Technical Service Bulletin

19 Coolant pipe seepage on turbocharger

19 17 88 2036167/7 May 26, 2017. Supersedes Technical Service Bulletin Group 19 number 17-82 dated March 21, 2017 for reasons listed below.

Model(s)	Year	VIN Range	Vehicle-Specific Equipment
A8, S6, S7, S8	2013 - 2015	All	4.0 T

Figure 1. Black, encrusted coolant residue (outlined area), coolant feed pipe (A), oil feed pipe (B), and coolant return pipe (C).

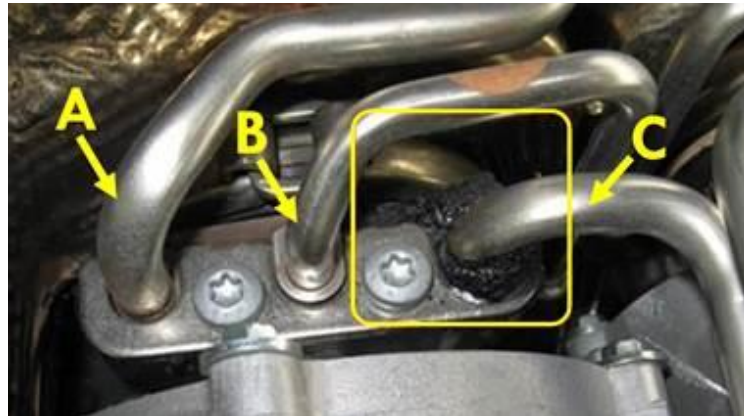
There may be slow coolant loss from the connections at the coolant feed pipe and the coolant return pipe. High temperatures cause the coolant to become encrusted on the connection flange of the turbocharger (Figure 1).

The resulting heat after switching off the engine can, under special operating conditions, lead to very high temperatures on the coolant seals of the turbocharger. This can damage the O-ring.

Optimized temperature-resistant O-rings on the coolant connection of the turbocharger together with an extended operating period of the auxiliary cooling pump after switching off the engine.

Replace the respective O-rings on the coolant supply and return pipes according to the table listed below:
